**Eurocode: EN 1991-1-2**

Car fires in car parks

Eurocode: EN 1993-1-2

Shear resistance of plate in non-uniform elevated temperature

New clause E.2.5(5)

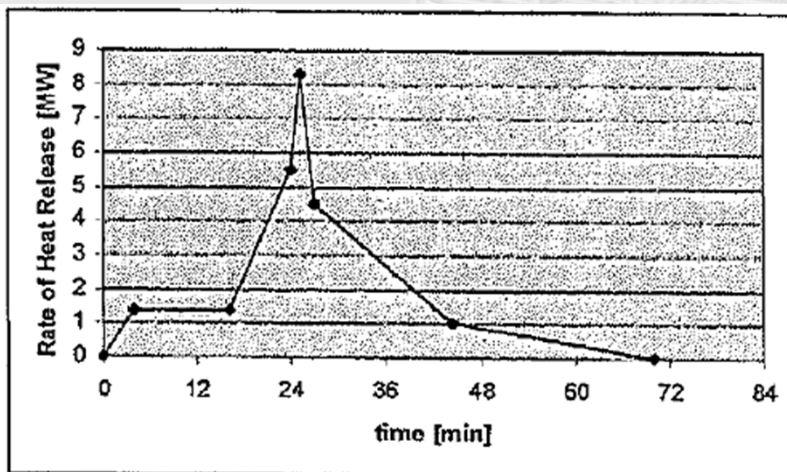
Reason: No information is given for car fires. Car fire is an important scenario in fire. No common rules are given so many different applications are used in real projects for this deeply studied subject. This means high financial risks for contractors.

The following rate of heat release should be used for one car in car park fires.
The following fire scenarios should be considered in design.
References: A lot of European researches.

New NOTE after clause 4.2.1(3)

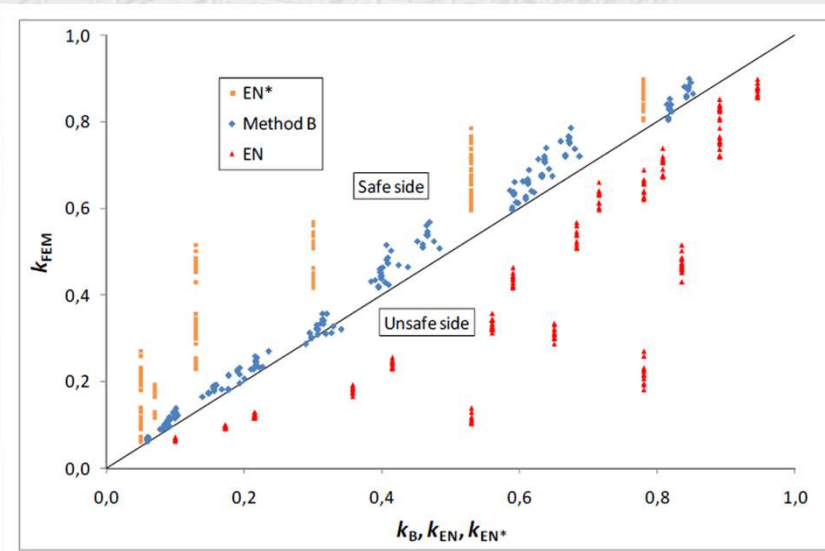
Reason: Using maximum temperature and EN rules (EN* in the figure) the design is very safe. Using mean temperature θ_{web} and EN rules (EN in the figure) the design is unsafe. Instead of reduction factor $k_{y,\theta,web}$ (class 1,2 and 3 cross-sections) or $k_{p0.2,\theta,web}$ (class 4 cross-sections) which are based on mean temperature, a reduction factor $k_{y,\theta,ref}$ (class 1,2 and 3 cross-sections) or $k_{p0.2,\theta,ref}$ (class 4 cross-sections) based on the new reference temperature θ_{ref} has shown to be relevant (Method B in the figure). Verification was done using a comprehensive non-linear FEM.
